AIR MOBILE FINAL SUPPLEMENT TO FINAL ENVIRONMENTAL IMPACT STATEMENT

MX: MILESTONE II
MARCH 1979

This document has been published as an addendum to the Draft Supplement filed on February 16, 1979. The Final Supplement consists of the Draft and this addendum.

Figure 1-1. Air mobile study areas.

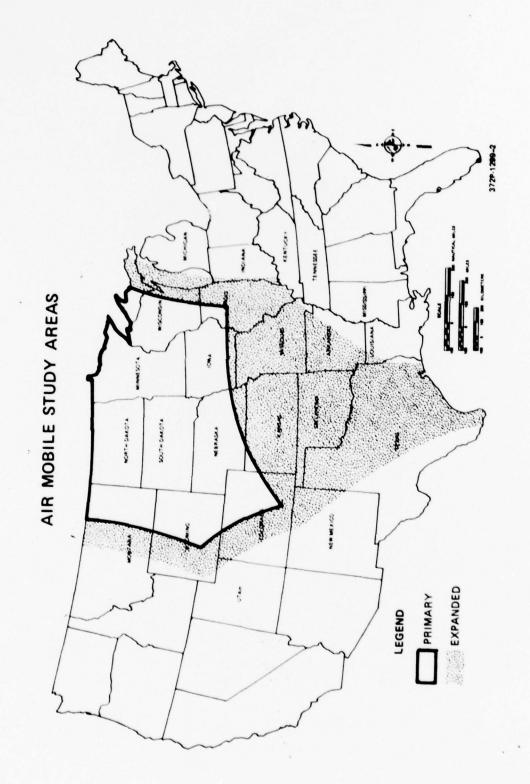
Figure 1-2 on Page IV-5 does not reflect the existence of the following Indían reservations in Kansas: Iowa in Kansas (Brown Co.); Kickapoo (Brown Co.); Pottawatomie (Jackson Co.); and Sac and Fox of Missouri (Brown Co.).

Figure 1-4. Areas having problems with one or more of the atmospheric pollutants.

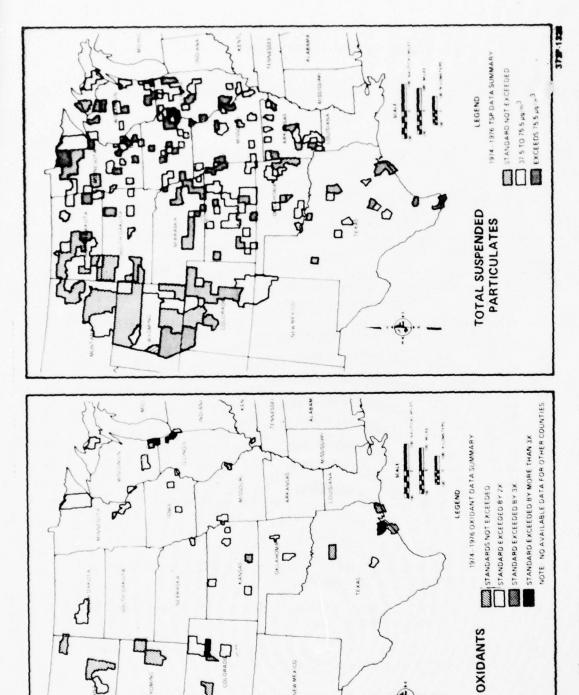
IV-5	The exclusion areas around cities (in orange) should be deleted from the figure.
IV-7	Figure 1-4 did not include oxidants. A revised figure is reproduced below.
IV-17	The caption for Figure 1-8 should read "Average annual rate of population change (1970-1975)."
IV-25	The page should be headed "3. ENVIRONMENTAL IMPACTS."
IV-26	Figure 3.1-1 did not include the entries for Airways Impeded, and is provided below in corrected form.
IV-37	Figure 3.2-1 did not indicate the Ldn levels and and is
